SAFETY EVALUATION
BY THE OFFICE OF NUCLEAR REACTOR REGULATION
SUPPORTING AMENDMENT NOS. 83 AND 84 TO FACILITY OPERATING
LICENSE NOS. DPR-29, and DPR-30
QUAD CITIES STATION UNITS 1 AND 2
COMMONWEALTH EDISON
DOCKET NOS. 50-254 and 50-265

RADIOLOGICAL EFFLUENT TECHNICAL SPECIFICATIONS
(RETS) IMPLEMENTATION - QUAD CITIES STATION
UNITS 1 AND 2 NUCLEAR GENERATING PLANTS

Figure 2. Gaseous Effluent Discharge Pathways.

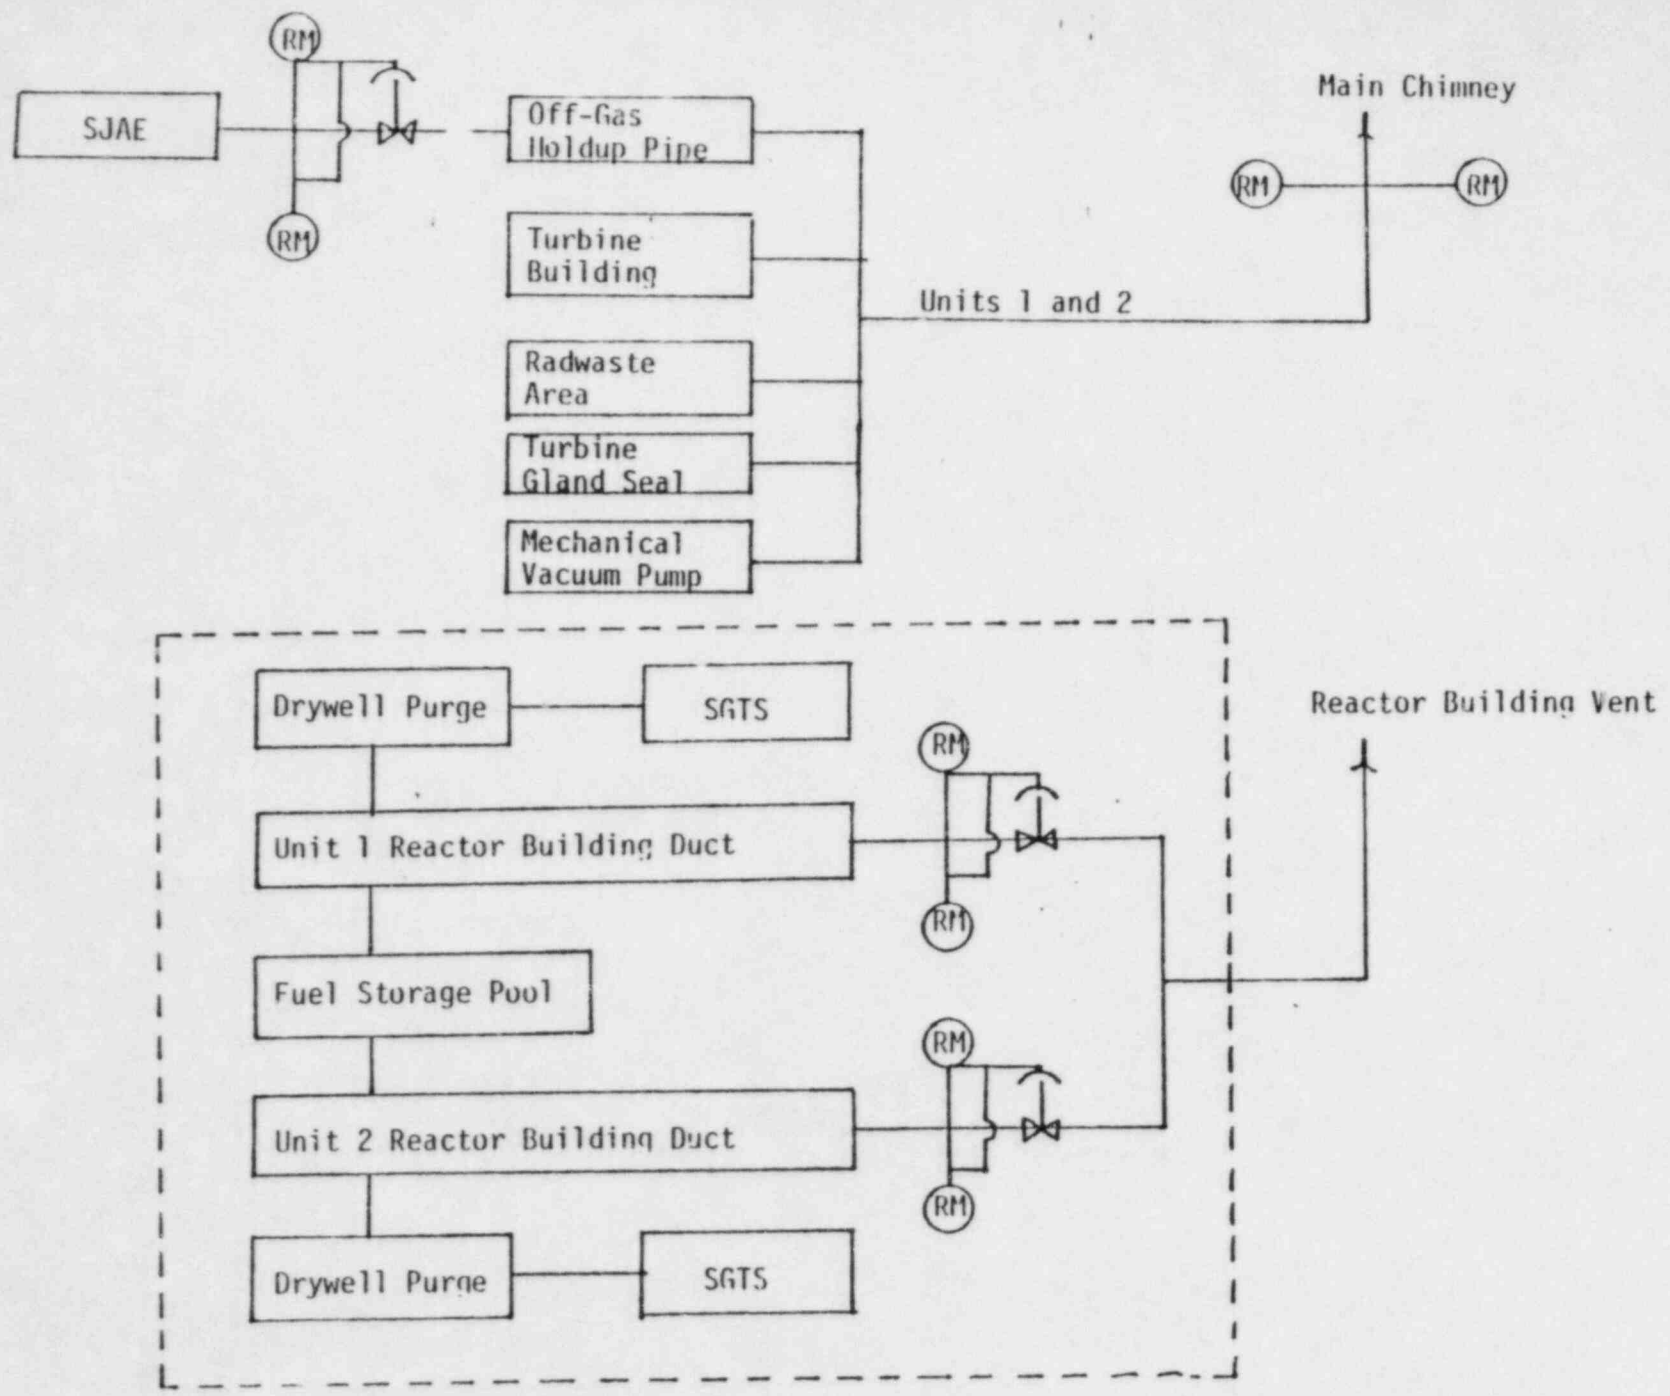
There are two radioactive gaseous effluent release points for the two-unit site. The reactor building effluents from each unit are collected in a common header before release and the two units share a common main chimney release. Effluents from the reactor building release point consist of releases from the reactor building and the fuel storage area. Effluents from the main chimney release point consist of radioactive gases from the main condenser off-gas treatment system, turbine building system, radwaste area, turbine gland seal condenser vent, and mechanical vacuum pump exhaust. A block diagram description of the radioactive gaseous effluent discharge pathway is shown in Figure 2.

The two radioactive gaseous effluent release points are monitored with adequate instrument surveillance being performed.

Releases from the main chimney are monitored with two radiation monitors and control room alarm annunciation occurs upon high radiation. The major source of radioactive noble gases in the main chimney is from each unit's off-gas system. Each unit's off-gas system has its own radiation monitor capable of isolating the off-gas release pathway. Off gases from the main condenser are monitored for gross gamma activity downstream of the steam jet air ejectors but prior to release to the main chimney. The detectors are located prior to the holdup pipe. A high radiation condition in the holdup pipe will initiate an interval timer which will isolate the off-gas system from the main chimney.

Releases of radioactive noble gases from each reactor building's ventilation duct are monitored prior to collection and release via the common ventilation stack. Each reactor building's exhaust duct has two monitors. A high radiation condition will initiate an alarm in the control room. Upon high-high radiation, the detectors will initiate alarm, automatic isolation of the reactor building ventilation system and initiate the standby gas treatment system (SGTS). Effluents from the SGTS are released via the main chimney.
